WELL NAME: JJ #1, API #: 043-05180, INSP. # 695108717

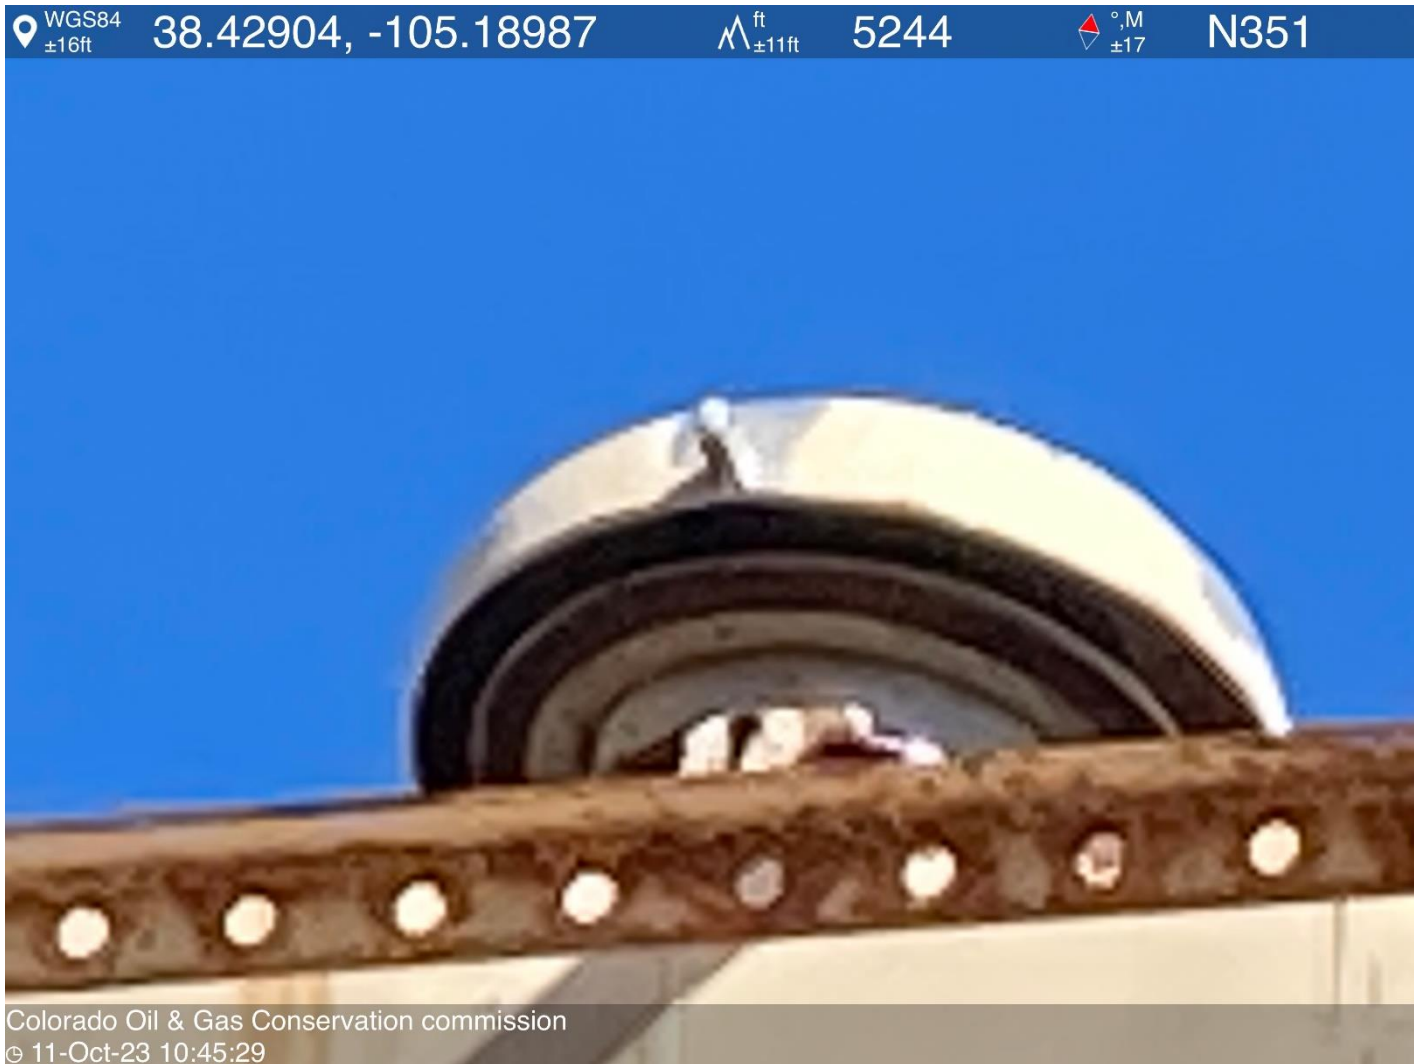
PHOTO 9: GAUGE HATCH OPEN OR NOT SEALED ON BOTH CRUDE OIL TANKS. Close and seal gauge hatches when not accessing tank per Rule 608.a.(9). THIS IS THE SECOND NOTICE FOR THIS CORRECTIVE ACTION IMMEDIATE ACTION IS REQUIRED.
